PL-NF-97-005
Rev. 3

Susquehanna SES Unit 2 Cycle 9

CORE OPERATING LIMITS REPORT

CORE OPERATING LIMITS REPORT REVISION DESCRIPTION INDEX		
Rev. No.	Affected Sections	Description/Purpose of Revision
3		<u>Revised MCPR Operating Limits</u> The Two Loop BOC to EOC power and flow dependent MCPR Operating Limits were revised, and the Single Loop MCPR Operating Limits were removed from the COLR. The revised MCPR Operating Limits are documented in Reference 1.

TWO LOOP POWER DEPENDENT MCPR OPERATING LIMIT
EOC-RPT OPERABLE / MAIN TURBINE BYPASS INOPERABLE
(BOC to EOC)
FIGURE 4.2-3

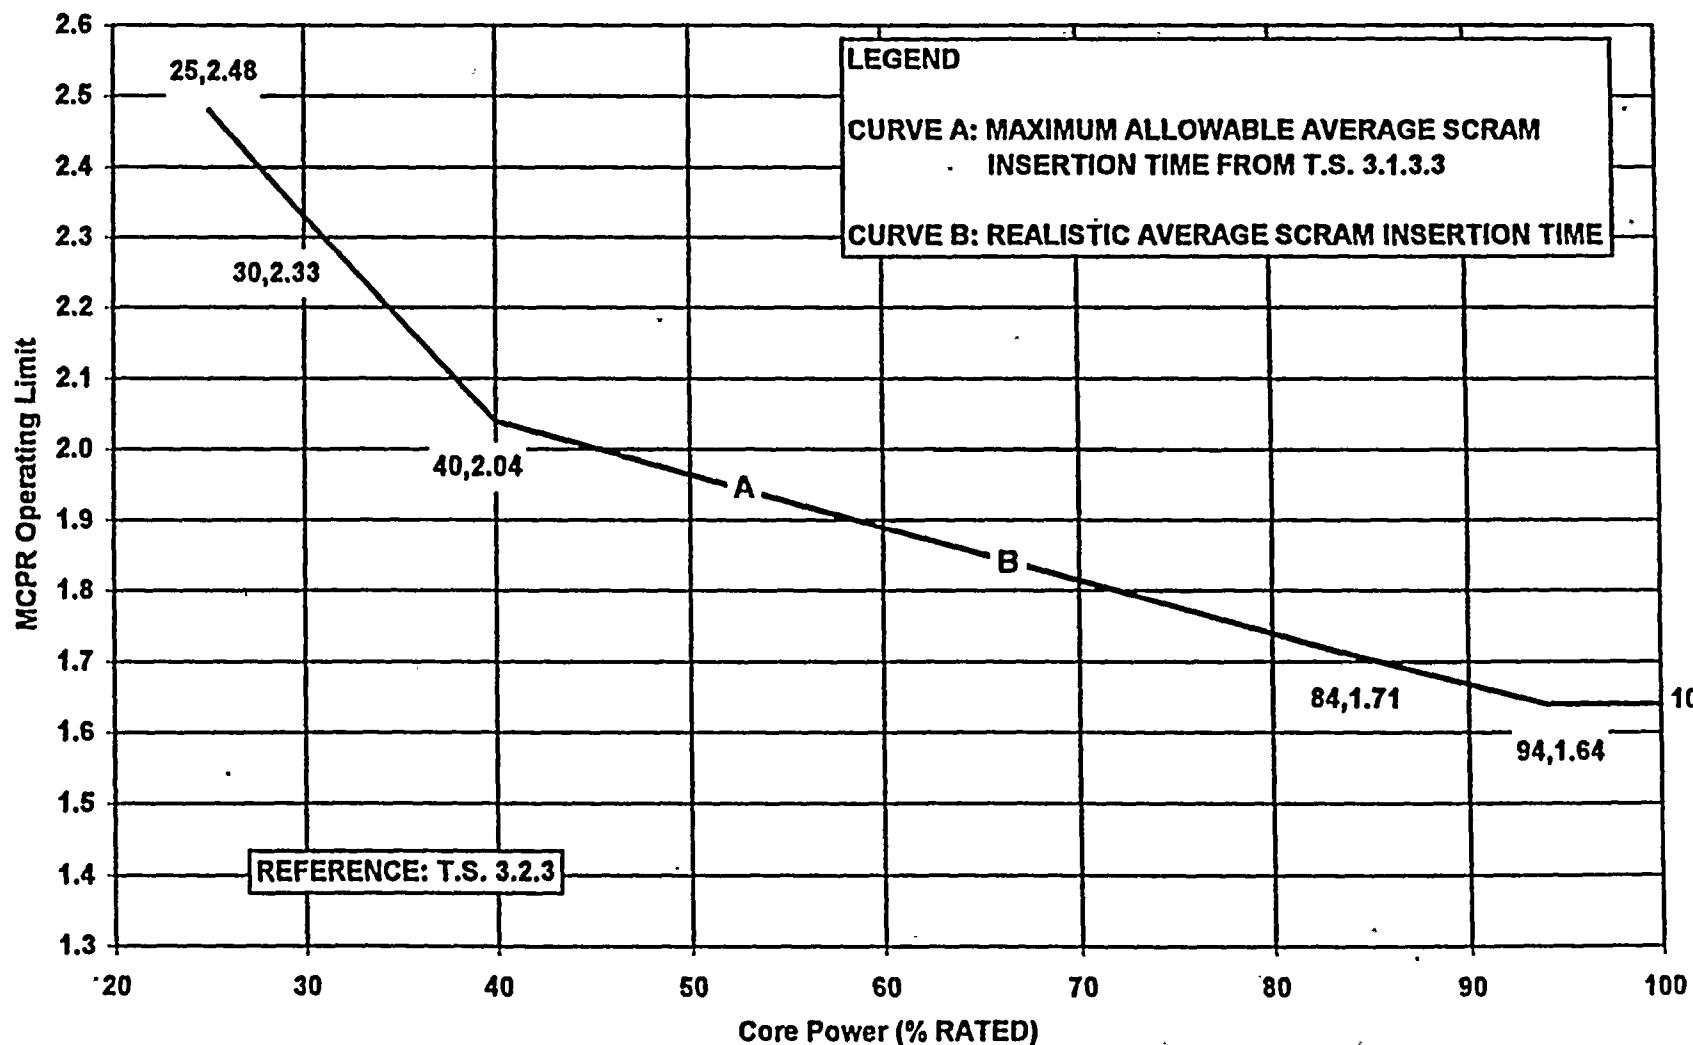
4.0	Revised MCPR OL Figures 4.2-1A, 4.2-2A, and 4.2-4. MCPR OL Figures 4.2-3A and 4.2-3B were removed, and Figure 4.2-3 was added. Table 4.3-1 was revised to include a new set of Realistic Scram Insertion Times.

Figure 4.2-3: EOC-RPT Operable / Main Turbine Bypass Inoperable from BOC to EOC
